### ADDENDUM No. 1

REQUEST FOR QUOTATIONS No.: 1220-040-2022-063

TITLE: Surrey RCMP HQ – Roof and Skylight Replacements

ADDENDUM ISSUE DATE: September 28, 2022

CONSULTANTS	
ARCHITECTS	
Grant & Sinclair Architects Ltd. Vancouver, B.C., Canada (604) 681-9191	
PROJECT <b>SURREY POLICE BUILDING CORPORATION of the DISTRICT of SURREY</b>	
SHEET TITLE <b>ROOF PLAN</b>	
DRAWN	SCALE
CHECKED	DATE
	SHEET No.
	DATE
	A8

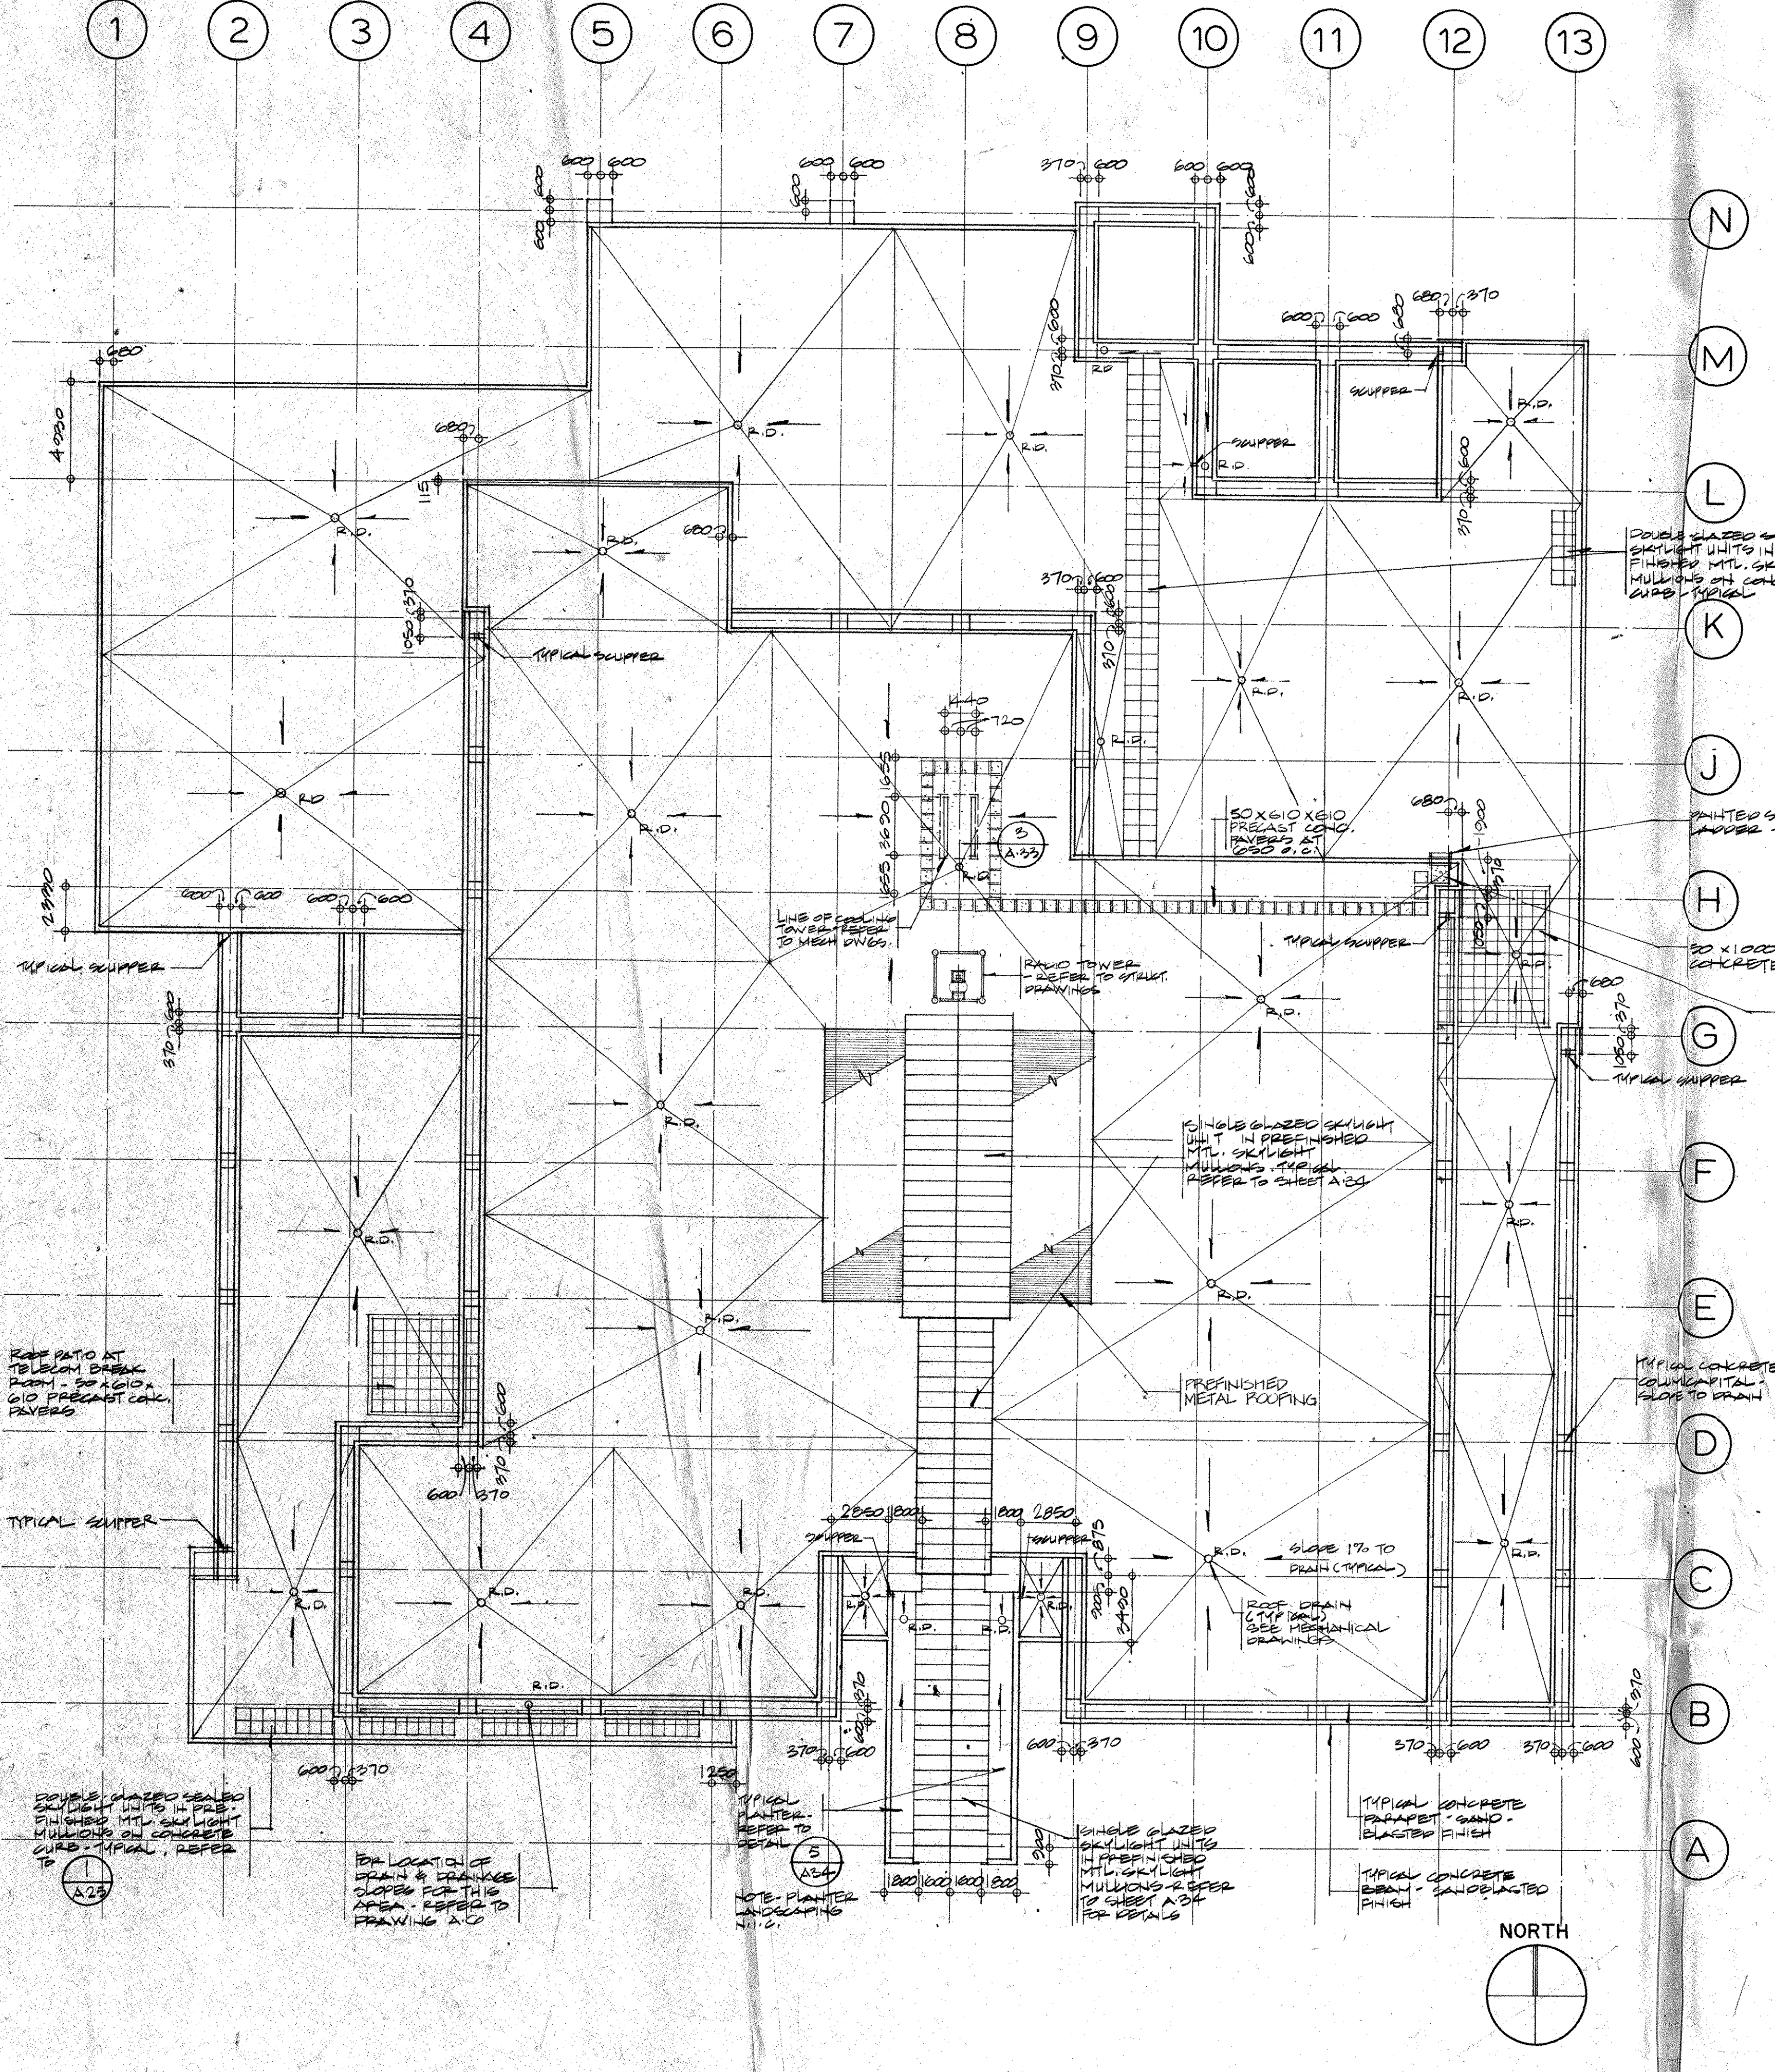
- Q4. At the interior there are three steel support structures under the skylights. Is the steel to remain and be reinstalled once the curb is built up or can it be removed? How is the steel attached to the substructure?

- A4. All existing steel support structures are to be removed and replaced at new skylight elevation, any cost for this is to be included in the general scope of work. Please refer to attached original IFC drawings, supplied for reference only – A8-Roof Plan and A25-Wall Sections.**

IRC #:	23675	PROJECT NORTH:	
W.O.#:	VR22-071SP		
SCALE:	1/16" = 1'-0"		
DATE:	SEPT. 2022		
DRN. BY:	B.W.	DWG.#:	R1(REV.1)
CHK. BY:	J.M.

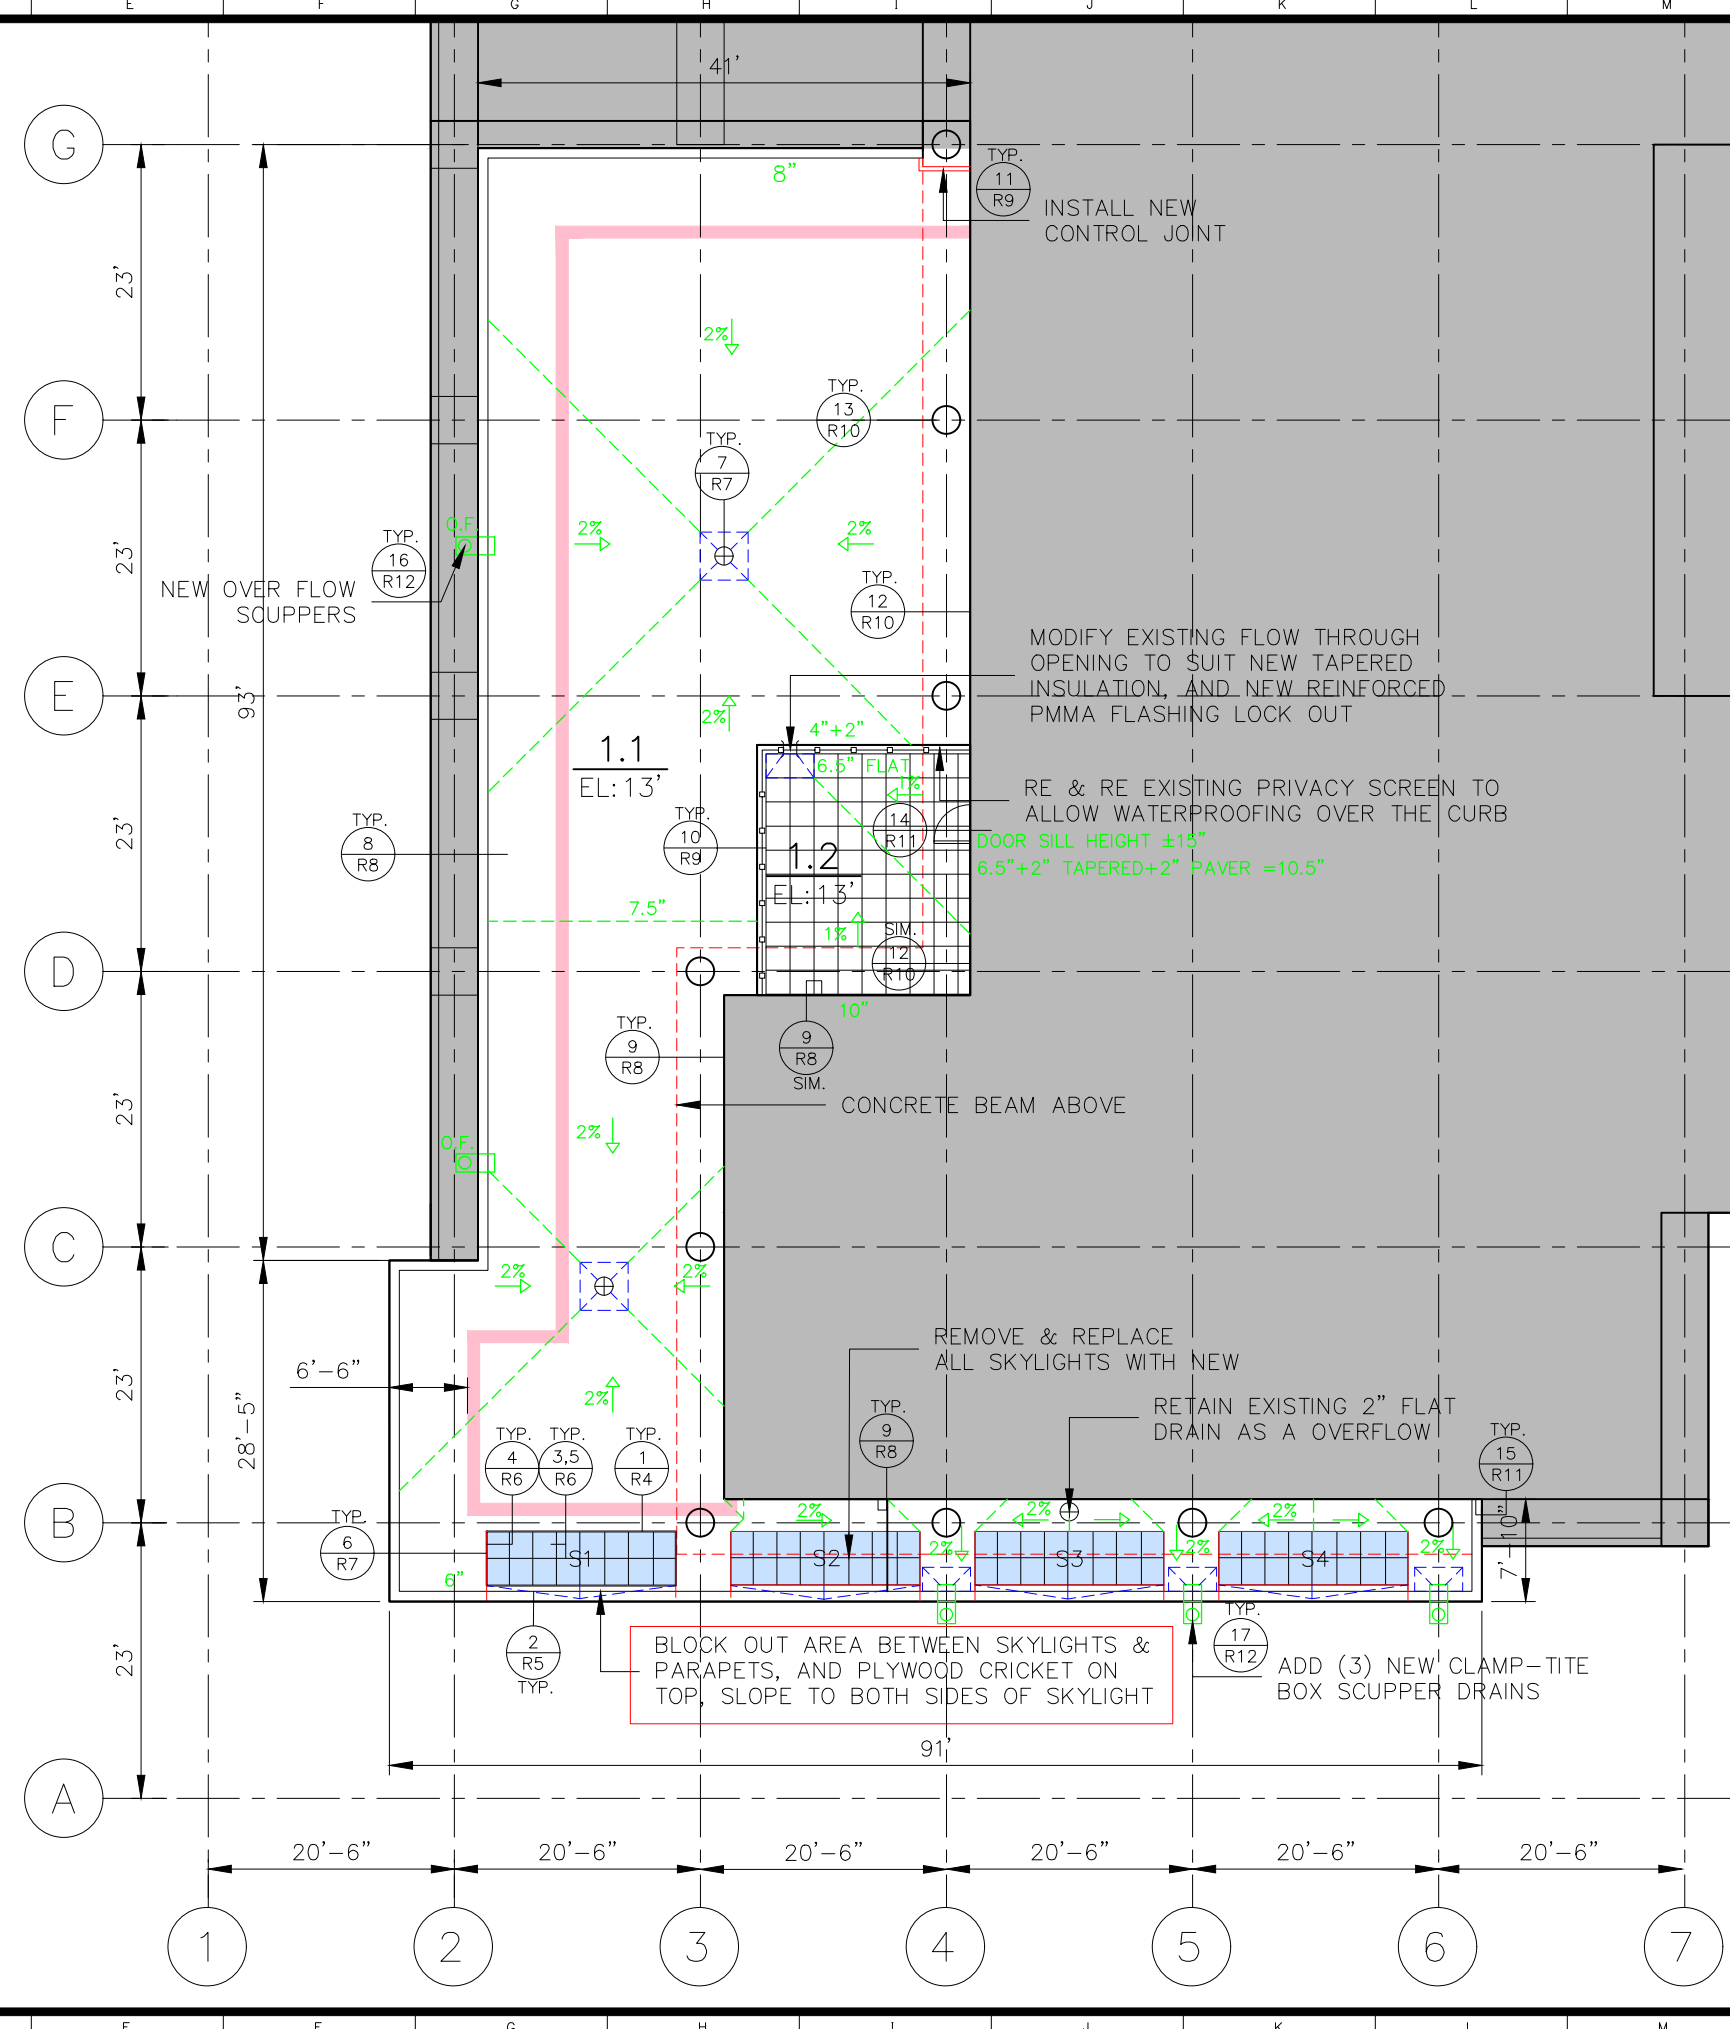
- 1. Contractor is to modify the parapet slope in order to slope towards the building at 4%. Remove the installation of a cap sheet membrane and the metal parapet cap from the scope of work at the areas surrounding the skylights only. Allow for installation of a new 8% plywood backslope cricket with shims, sloping away from the skylight, in order direct water**

around the skylight and onto the roof level. Hold back the wood cricket roughly 4 inches from the exterior parapet edge. Install a reinforced PMMA liquid membrane over the entire base sheet, and lap onto the surrounding cap sheet membrane around the skylight area, SBS sheet membrane is not required in this area. Install PMMA liquid membrane per the manufacturers written installation instructions. Install a continuous metal drip edge at the entire parapet, and hold back the metal cap roughly 100mm (4") from either side of the skylight edge to allow drainage around the skylights. Full metal cap is not required at the skylight, only a drip edge. Skylight wood curb height is to be adjusted to suit the revised finished roof level above the cricket. Refer to revised Drawings R1 (REV.1), R4 (REV.1), R5 (REV.1).
